AGENDA ITEM 6
April 27, 2021
Worksession

Council worksession to discuss the recommendations of the Planning, Housing, and Economic Development (PHED) Committee regarding Planning Board Draft of the Ashton Village Center Sector Plan.

SUBJECT: Ashton Village Center Sector Plan

PURPOSE: Worksession - Review PHED Committee Recommendations

Image 5 – CLV Analysis – Future Conditions

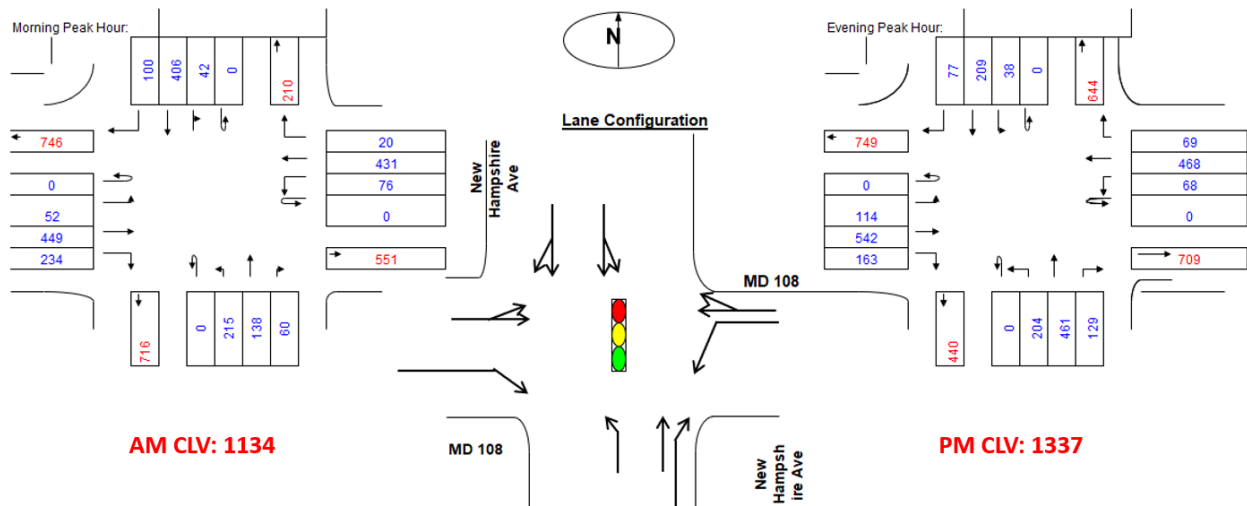
Council staff asked Planning staff to develop such a forecast, and its analysis is on ©4-11. The analysis projects that, adding the traffic from a reasonable assumption of the remaining buildout in the Plan area, the congestion in the evening peak would rise to 1,337 CLV, only 1% better than the 1,350 CLV standard of adequacy. Assuming that through traffic will grow by 10% over the next 20-25 years would bring the congestion to 1,496 CLV in the evening peak hour, which would exceed the GIP adequacy standard by about 11%.³ Thus, it can be concluded that there is a good chance the intersection will fail during the lifetime of the Plan without remediation.

Image 5 – CLV Analysis – Future Conditions + 10%

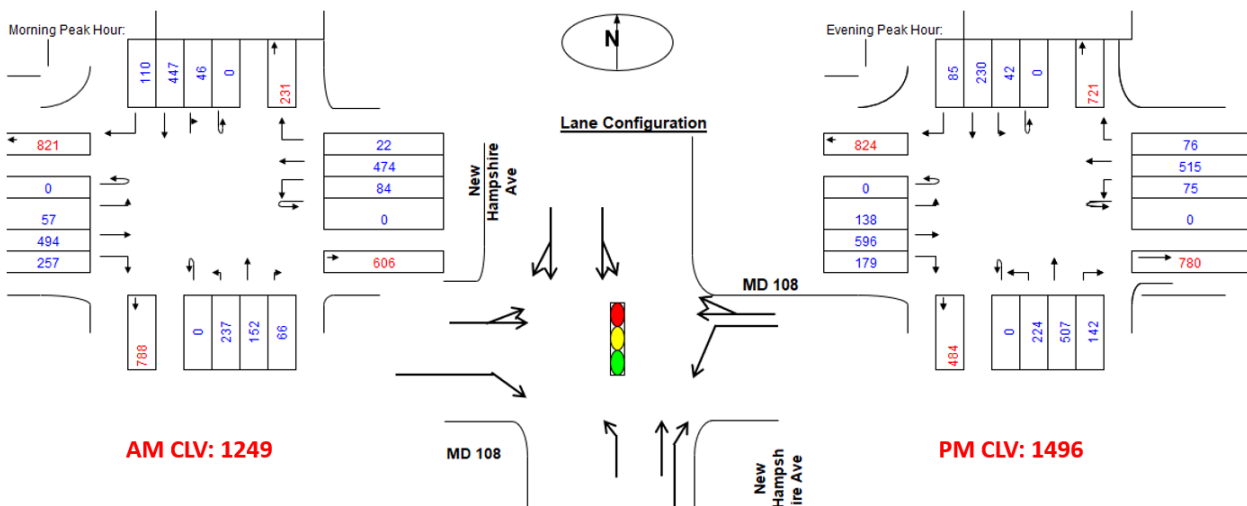
Under this “future conditions + 10% growth” scenario, the CLV threshold in the PM peak hour period threshold is significantly exceeded; this amounts to an equivalent average vehicle delay of roughly 1 minute. The AM peak hour remains below the 1350 congestion standard.

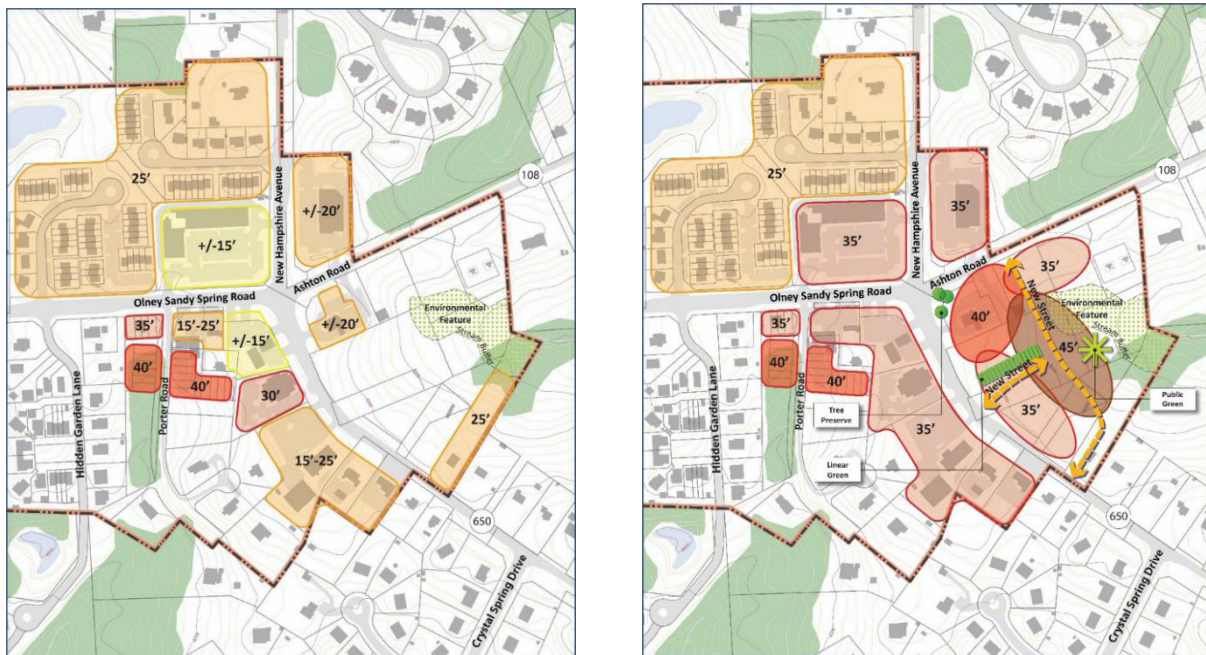
The Council received testimony from Francoise Carrier on behalf of the Nichols Development Company, the master developer of the approximately 9.3 acres of land in the southeast quadrant. Ms. Carrier requests that the recommendation that a majority of buildings should contain pitched roofs be deleted. In addition, she asks that the text for Figure 4 on page 39 clarify that it depicts suggested development patterns for the properties in the southeast quadrant, not maximum building heights. In fact, Figure 4 does note this; however, combining maximum zoning height and suggested maximum height (that does not equal the zoning height) on one map is confusing.

PHED Committee recommendation (2-0): Councilmembers Riemer and Friedson concur with the Planning Board’s areawide community design recommendations, except for the reference to Figure 4. The Committee recommends that the right side of Figure 4 on page 39 be removed from the Plan and the reference to Figure 4 under the eighth bullet above be deleted.

- **Clarify that height bubbles in Figure 4 show suggested development pattern, not maximum building heights.**
- **Give Planning Board discretion to approve alternative design solutions to avoid rigid application of design guidelines.**
- **Increase maximum length for residential buildings on main roads from 80 feet to 90 feet.**
- **Increase maximum length for mixed-use buildings not on main roads from 120 feet to 150 feet.**
- **Delete directive for a majority of mixed-use buildings to have pitched roofs.**
- **Ensure that Implementation Advisory Committee includes diverse local viewpoints.**

1. Clarify that height bubbles in Figure 4 show suggested development pattern, not maximum building heights.

Figure 4, reproduced below, includes a series of ovals that could be viewed as imposing rigid height limits in various sectors of the SE Quadrant Property. The Planning Board discussed building height for this site extensively, and nothing in that discussion suggested that building heights should be limited to 35 feet in any given location, or that buildings of similar height should be clustered together in certain areas. On the contrary, the Sector Plan specifically recommends that building heights vary from one building to the next. Moreover, the focus of discussion before the Planning Board was on creating appropriate transitions to surrounding development, with lower building heights at the edges and higher building heights at the corner and in the interior of the site.

To avoid circumscribing building heights in a way that will be counterproductive and inconsistent with other elements of the Sector Plan, the caption of Figure 4 should be revised as follows:

Figure 4. Existing building heights (left) and **suggested development patterns** ~~maximum proposed building heights~~ (right) in the Village Core neighborhood and surroundings. **Figure 4 includes,—including** suggested building heights for buildings in the southeast quadrant showing the tallest buildings in the interior of the quadrant and maintaining a transition along the state highways, **but this exhibit is not intended to limit specific building heights in any location except as required in other sections of this Plan.**
